Administrative Staff Report

Project Name: Silverdale Self Storage

Type of Application: Administrative Conditional Use Permit (ACUP)

Permit Number: Permit # 18-00317

BUILDING 1 EAST ELEVATION
SCALE: 1/8" = 1'-0"

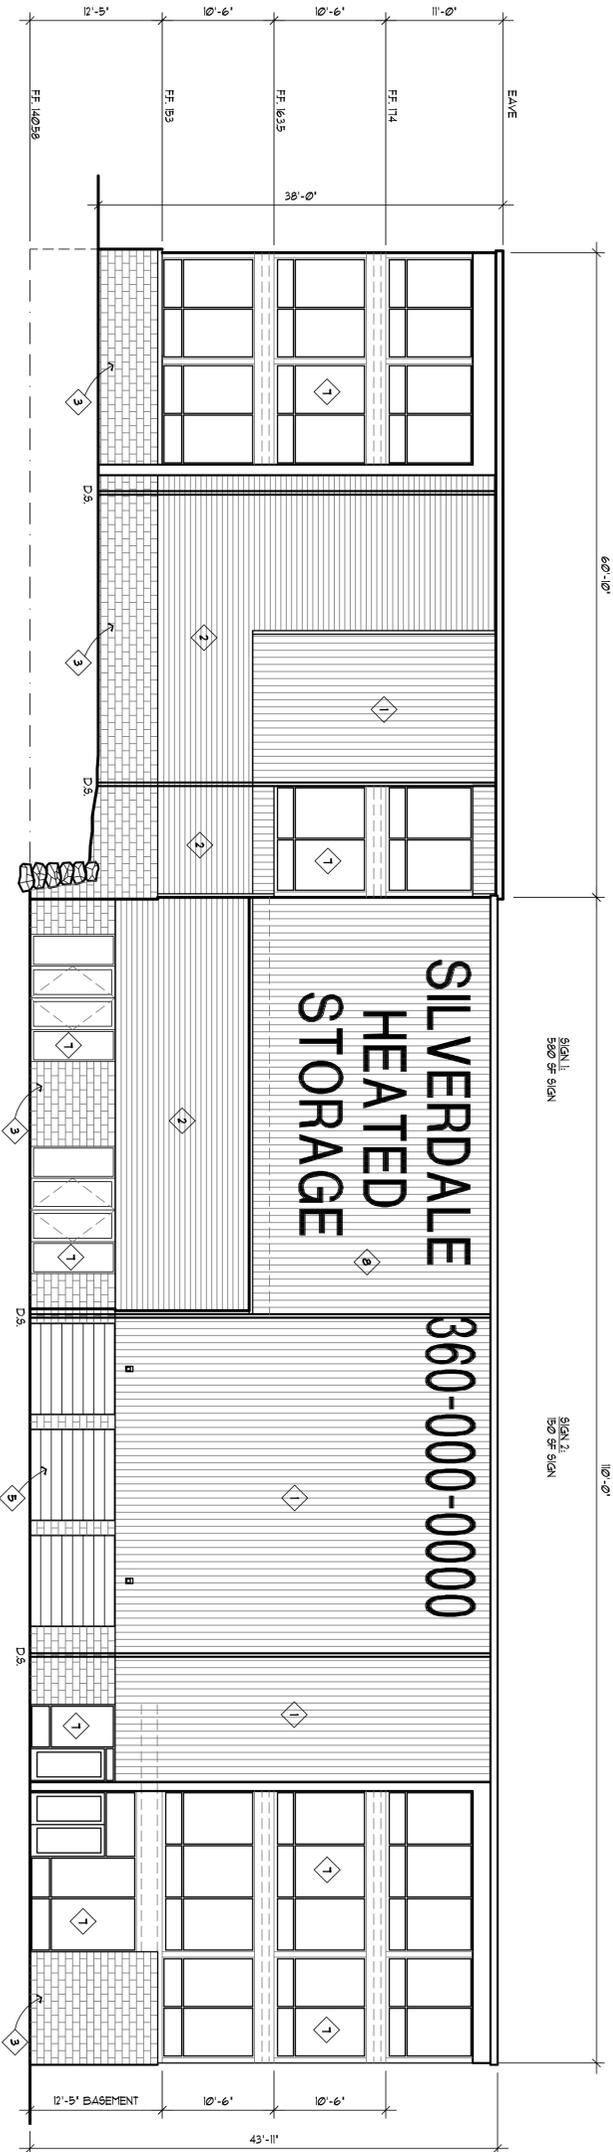
Staff Response: Only Building 1 faces the street and the ground floor total wall area is approximately 1,366 square feet (12 feet, 5 inches or 12.42 feet X 110 feet = 1,366.2 square feet); 50% of the ground floor wall area required in permeable surface is 683 square feet. The architectural drawing shows approximately 398 square feet in permeable surface. Therefore, the permeable area shown is approximately 285 square feet below the requirement. Based on the architectural drawings submitted with the ACUP, Building 1 will be conditioned to require at least 50% permeable surface wall area on the ground floor. The architect will need to show and provide the calculations for the total ground floor wall area and the ground floor permeable surface area as part of the commercial building permit for Building 1. The other alternative would be to request a variance to this standard. Based on the calculations provided above, a Zoning Variance - Administrative would be the appropriate application, which applies to a variance greater than 10% but less than or equal to 25%. For a variance to be supportable it will need to comply with the requirements outlined at KCC 17.560 Variances.

Staff Response: It is unclear if an awning or overhang is proposed over the office entrance. As a result, the project will be conditioned to provide a rain protection feature over the office entrance.

1. All required permits shall be obtained prior to commencement of land clearing, construction and/or occupancy.
2. Commercial Building Permit 18-04330 for Building 1, east elevation, shall include a drawing that shows compliance with Silverdale Design Standards, Provost Commercial District 11.4.2(A) and includes the ground floor total wall area and the total wall area of permeable surfaces.

3. Commercial Building Permit 18-04330 for Building 1 shall include a drawing that shows compliance with Silverdale Design Standards, Provost Commercial District 11.4.2(C). Building 1 shall show a rain protection feature over the office entrance. This requirement shall be shown on the east elevation drawing.
